**QUALITY ASSURANCE -- NON-CONFORMANCE REPORT**

**Location:** Changxing Island, Shanghai, P.R. China **Report No:** NCR-000729  
**Prime Contractor:** American Bridge/Fluor Enterprises, a JV **Date:** 05-May-2010  
**Submitting Contractor:** Zhenhua Port Machinery Company, Ltd (ZPMC), Changxing Island **NCR #:** ZPMC-0692

**Reference Description:** Missed MT Indication by QC in OBG Segment 7BW at Longitudinal Diaphragm to FB Weld

**Dear:** Mr. Charles Kanapicki  
**Job Name:** SAS Superstructure

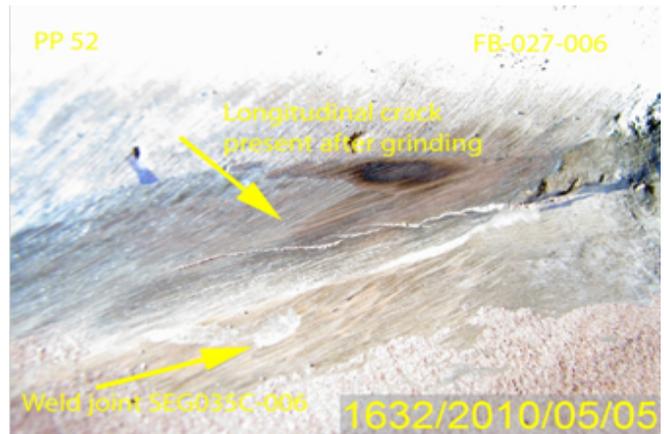
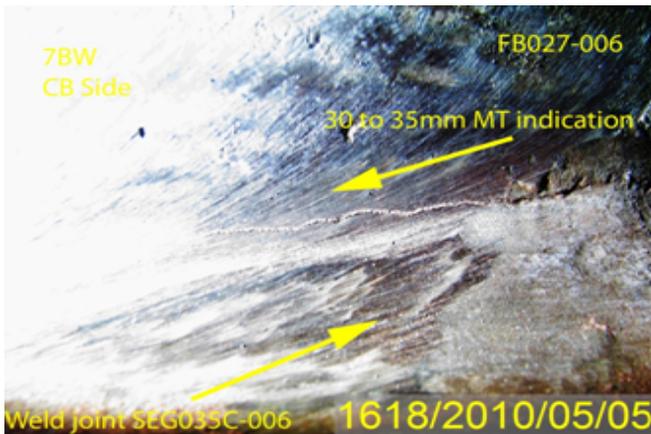
During the Quality Assurance (QA) Magnetic Particle Testing (MT) review of base metal and welds located on Segment 7BW, this QA Inspector discovered the following issues:

- One (1) longitudinal linear crack measuring approximately 30 to 35mm in length.
- The weld is identified as SEG035C-006.
- The weld is a CJP T-joint joining the longitudinal diaphragm (Piece mark LD018-012) to floor beam web (Piece mark FB027-006).
- Location of this weld joint is at panel point PP52 Cross Beam side of the segment.
- The indication is clearly marked on the material.
- Lift 7 West is located in the OGB Trial Assembly Area.

The Notice of Witness Inspection Number (NWIT) is 005670. The indication is located inside the area that has been previously tested and accepted by ZPMC Quality Control (QC) personnel and ABF QC personnel. According to the contract documents ZPMC Quality Control (QC) is required to perform 100% MT of this weld.

**Reference Resolution:** ZPMC has repaired the indications referenced in the NCR and is providing the NDT report to show that the weld is now acceptable. Based on this ZPMC requests closure of this NCR.

This proposed resolution is acceptable. The documentation received is sufficient and the Department concurs that Non-Conformance ZPMC-0692 is closed.

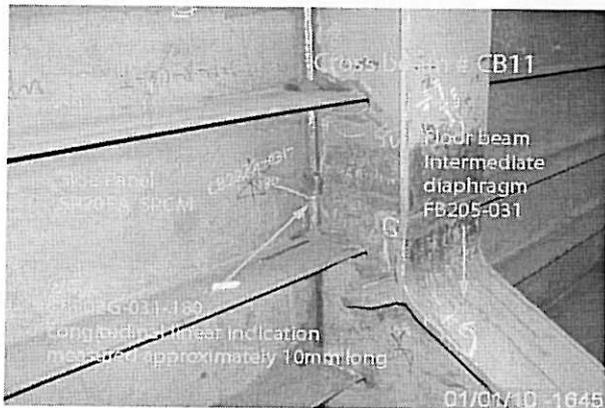
During the Quality Assurance Magnetic Particle Testing (MT) review of welds located on Orthotropic Box Girder (OBG) Crossbeam CB11, the Quality Assurance Inspector (QA) discovered the following issue:

-Two (2) longitudinal linear indications measuring approximately 10mm and 8mm in length.

-The welds are identified as: CB202G-029-087 (8 mm) and CB202G-031-180 (10 mm).

-Weld CB202G-029-087 is a horizontal Fillet Weld joining the Side Panel (SP205A) Seismic Performance Critical Member (SPCM) stiffener connecting to the Floor Beam Intermediate Diaphragm (FB205-029).

-Weld CB202G-031-180 is a vertical Fillet Weld joining the Side Panel (SP205A) SPCM stiffener connecting to the Floor Beam Intermediate Diaphragm (FB205-031).

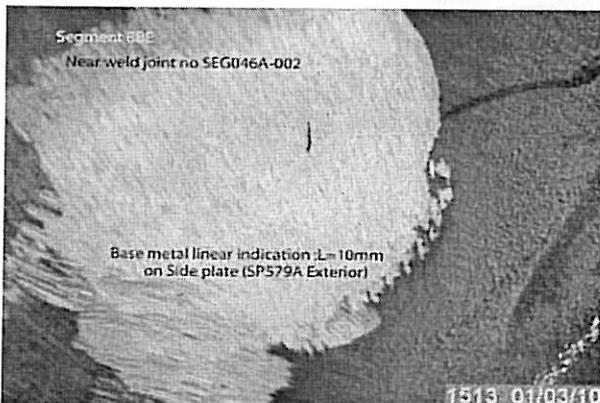
During the Quality Assurance Magnetic Particle Testing (MT) review of welds located on OBG Corner Assembly 8BE, this Quality Assurance Inspector (QA) discovered the following issue:

- One (1) linear indication that measured approximately 10mm in length.
- The linear indication was discovered in the base metal at SP579A (PL1043A Exterior).
- The adjacent weld is identified as: SEG046A-002
- This weld joins SP579A (PL1043A) to SP539A (PL1042A).
- This base metal linear indication was located in a temporary attachment removal area.
- The OBG Segment 8BE is located in the outside yard, south side of the Bay14.

The Notice of Witness Inspection Number (NWIT) is 004978. The indication is located inside the area that has been previously tested and accepted by ZPMC Quality Control (QC) personnel. As per the contract documents, ZPMCs QC personnel are required to perform 100% Magnetic particle inspection of this weld.
